9057-9059 16TH AVE SW
SDCI#3039754-LU

PROJECT BRIEF

The proposed project include the removal of three existing structures and the construction of an apartment building containing 72 Small Efficiency Dwelling Units (SEDUs). No parking provided.

GUIDANCE SUMMARY

SITE DESIGN

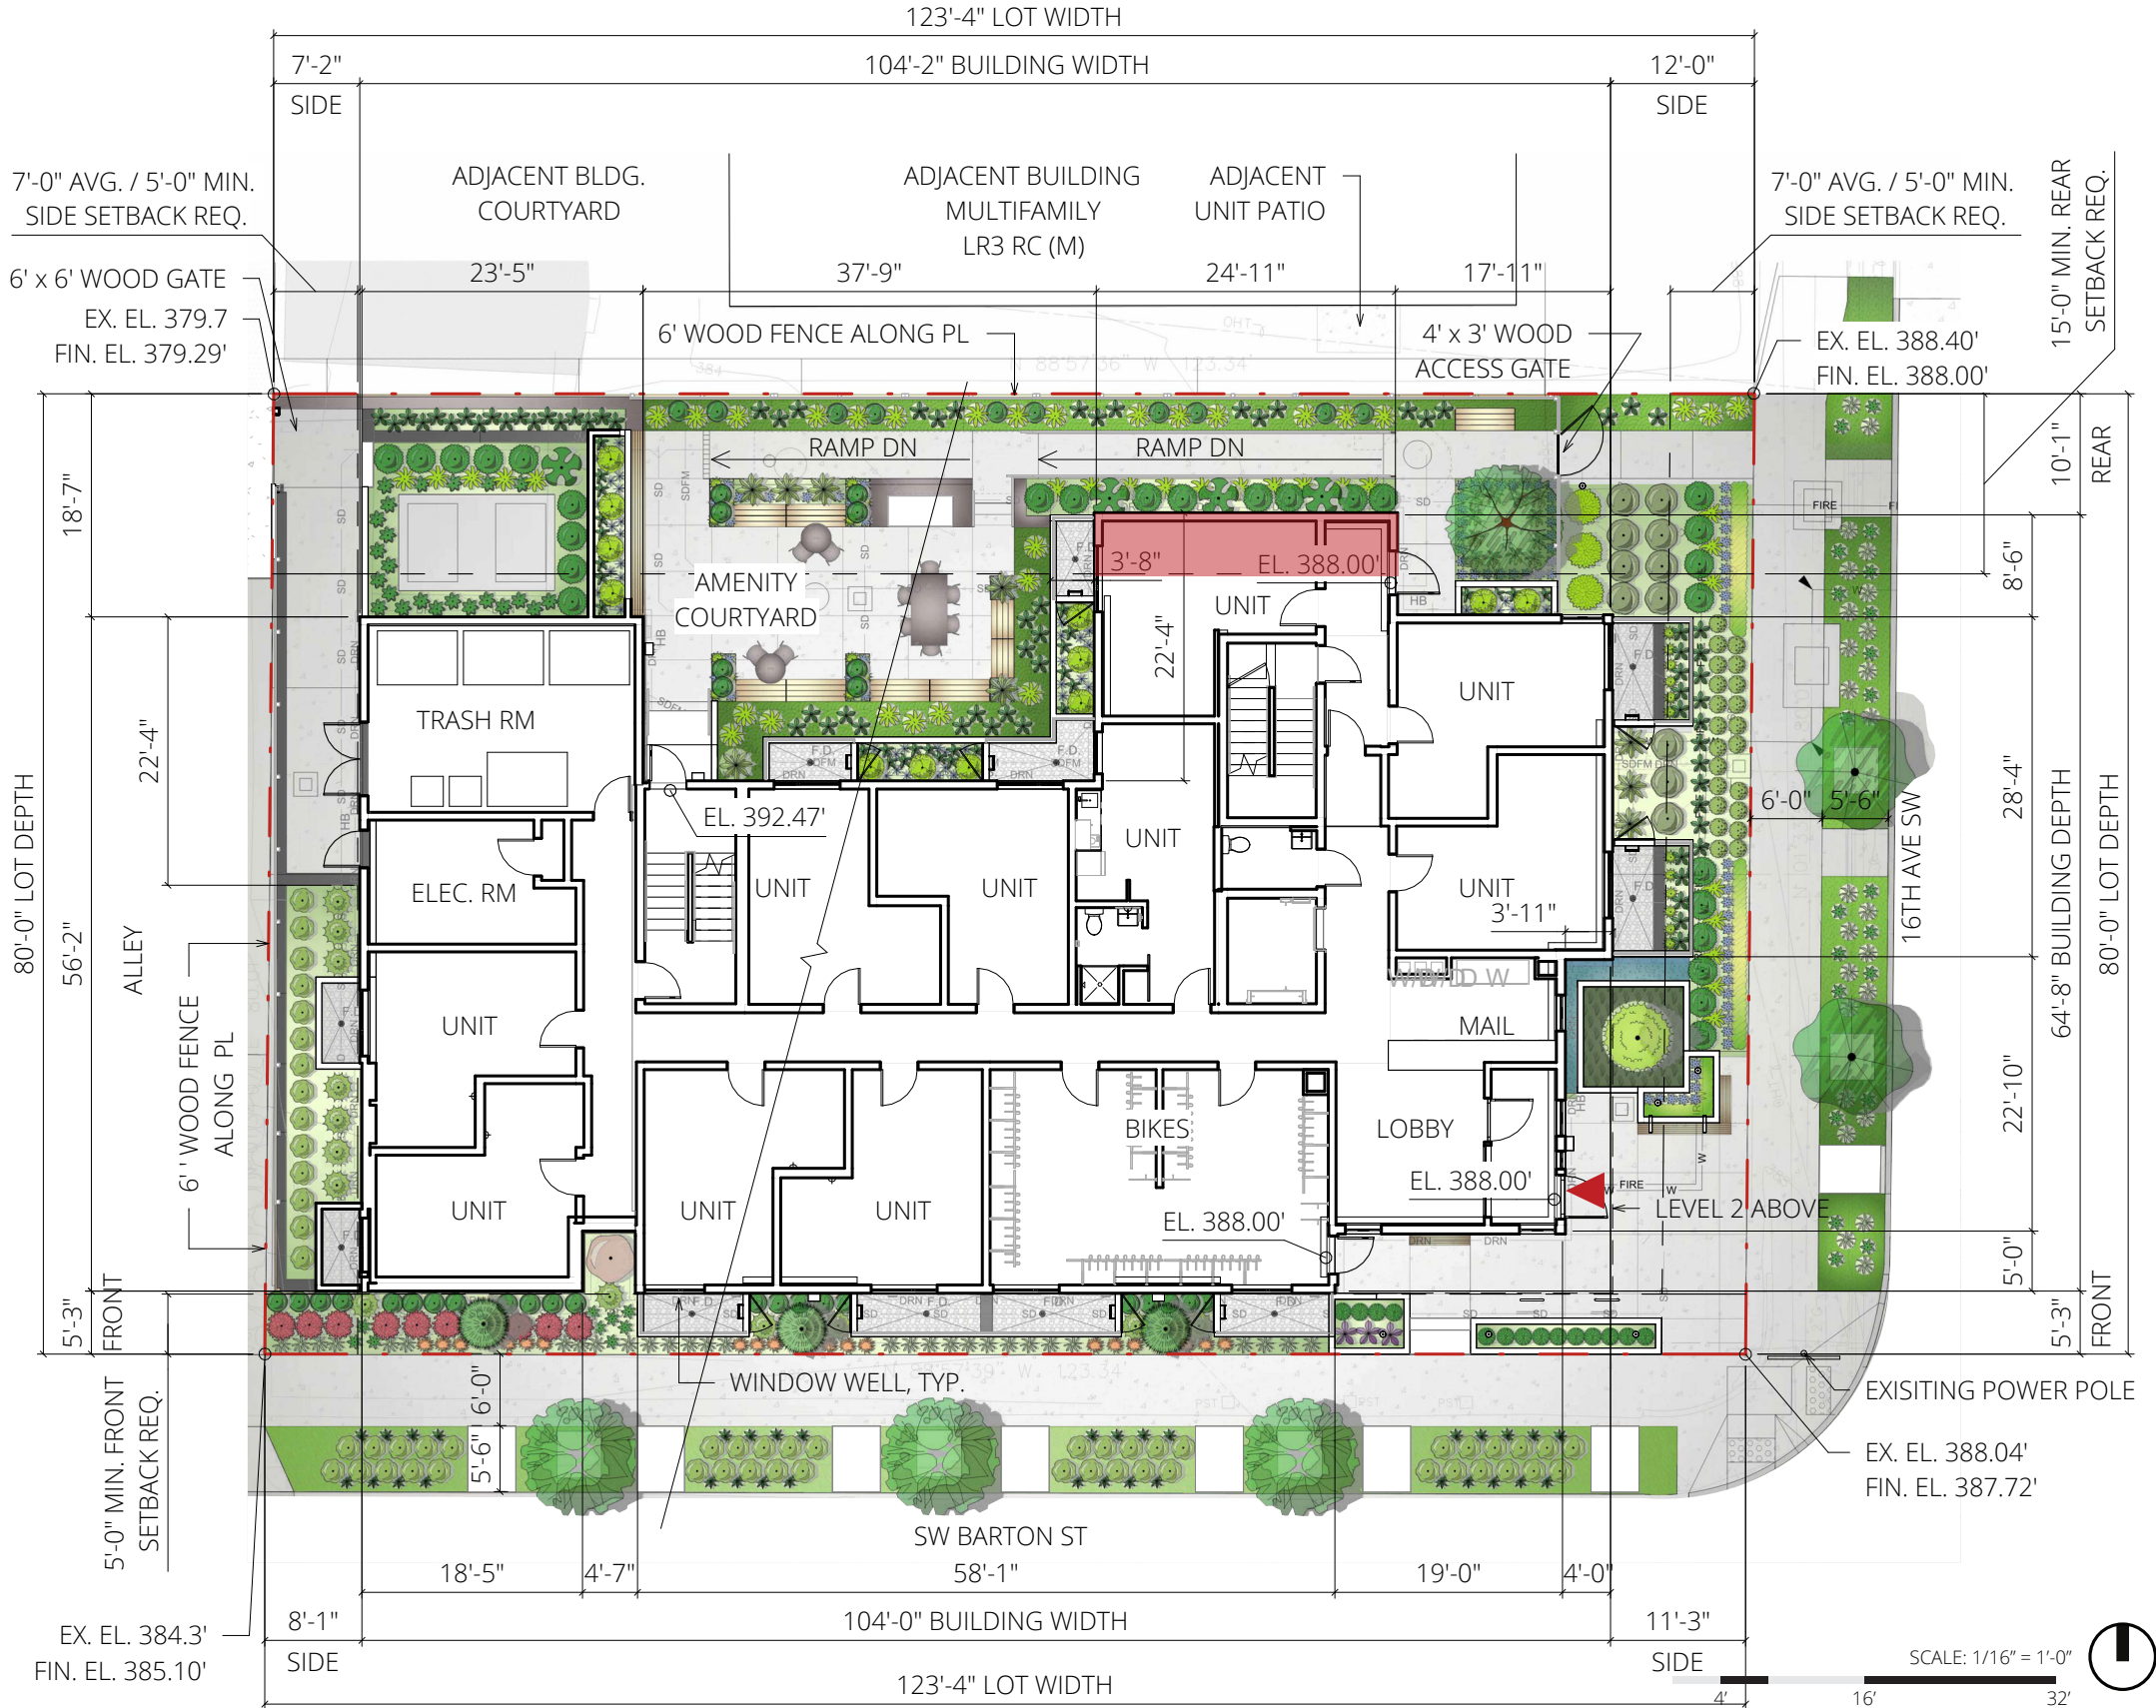
g) Trash storage is proposed within the building, accessed via a paved path from the alley. Staff supports locating the trash storage within the building, which reduces possible impacts of these facilities on building aesthetics and pedestrian circulation.

h) Thoughtfully design the alley condition and pathway to trash storage room to avoid conflict with vehicles in the alley. Clearly delineate the pedestrian path from the alley, being mindful of safety and security concerns noted by public comment.

1. It appears a six foot fence is proposed along the alley, with a gate at the north property line. Please clarify the location of this fence and describe how it may or may not impact access to the trash room.

At the alley edge:

- A 6' wood fence is specified along the entire length of the alley property line to provide security and privacy for units along the west side of the building.
- A ramp dedicated to solid waste service, providing a direct path from the interior trash room to a collection point in the alley.

DEPARTURE REQUEST: REAR SETBACK

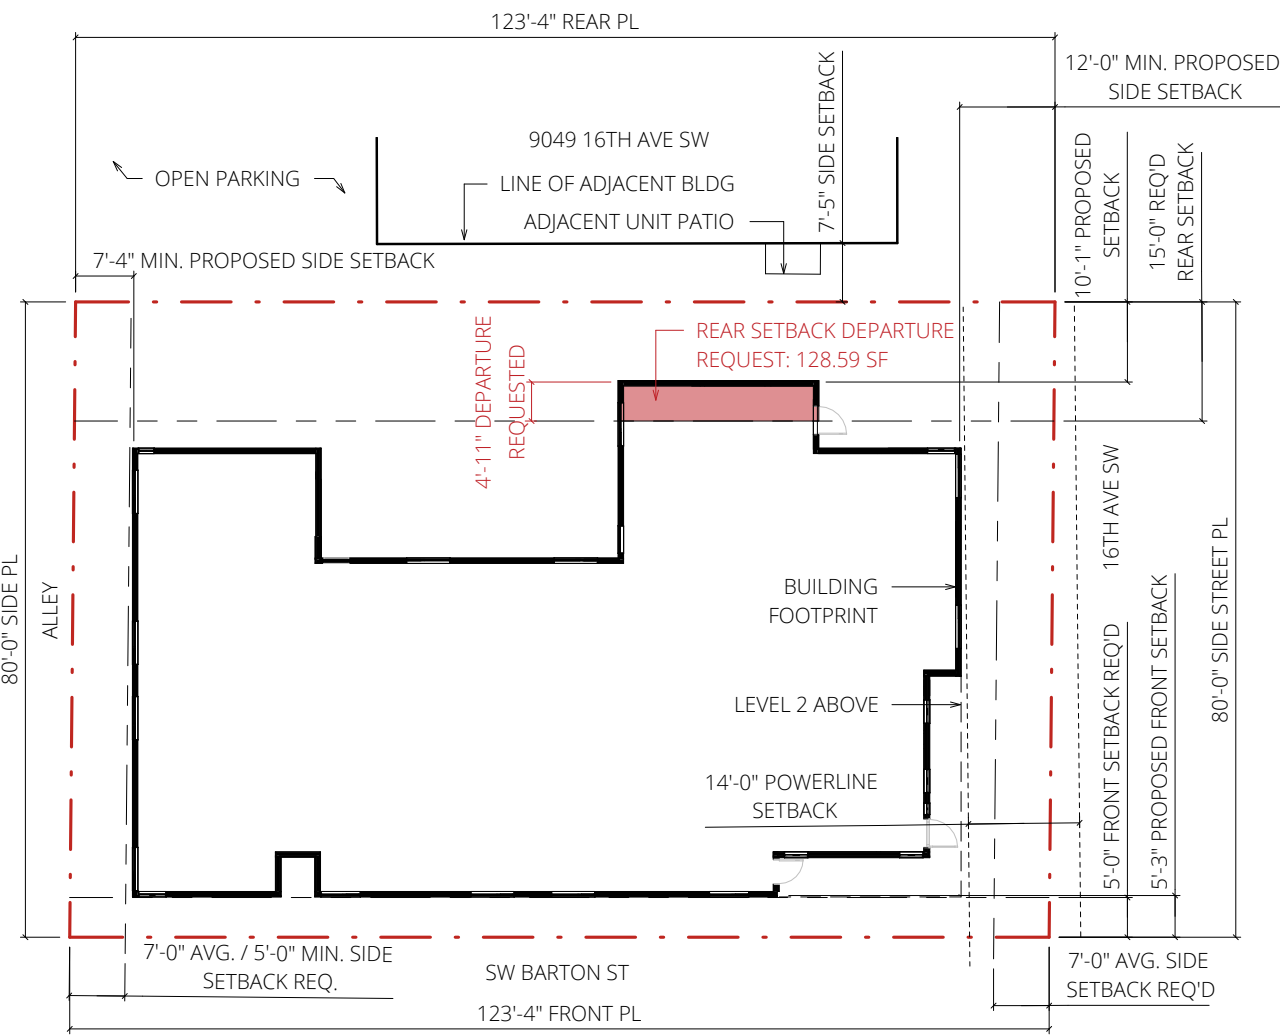
SMC 23.45.518.A - SETBACKS
Required: 15' Rear Setback
Proposed: 10' - 1" Rear Setback
Departure: 4' - 11" Encroachment Into Rear Setback (33% reduction of the required 15'-0" rear setback).

A departure is requested to reduce a portion of the required rear setback from the code required 15'-0" to 10'-1", a 33% reduction of the required setback. The departure distributes massing in a way that better responds to the Design Guidelines for this site and surrounding context than the prescribed Land Use Code requirements of section 23.45.518.A.
The surrounding context is underdeveloped and lacks substantial examples of recent design (see pg. 29 for context analysis). The proposed massing establishes a precedent in accordance with the Seattle Design Guidelines for future development in the surrounding area. See page 29 for additional analysis.

CS2-B.2 Connection to the Street:
The departure allows the massing to frame a space that is readily visible from the public way. The 'borrowed view' includes the east facing wall with windows, an Eastern Redbud tree, dense planting and small seating area. This composed area brings an on-site amenity adjacent to the ROW, and visual interest closer to the street.

CS2-C.1 Corner Sites
The departure responds to the corner site condition. Even though the north yard is the 'rear', it acts as a side yard. The northeast corner creates a transition area that steps the massing back and towards the adjacent property.

CS2-D.1 Existing Development and Zoning:
The departure responds to the anticipated street frontage rhythm of 16th Ave SW as adjacent sites undergo in-fill development. Reducing the rear setback, which functions as a side setback along 16th Ave SW, is more in-line with the typical 7' average setback required on adjacent sites. At 10'-1", the proposed setback is approximately the average of a rear setback and side setback.

CS2-D.5 Respect for Adjacent Sites
The departure strategically pushes the bulk of massing towards the two street frontages while carving out an interior courtyard for the residents. The increased modulation along the north reduces daylighting impacts and allows for a generous buffer to the adjacent neighbors (present and future).
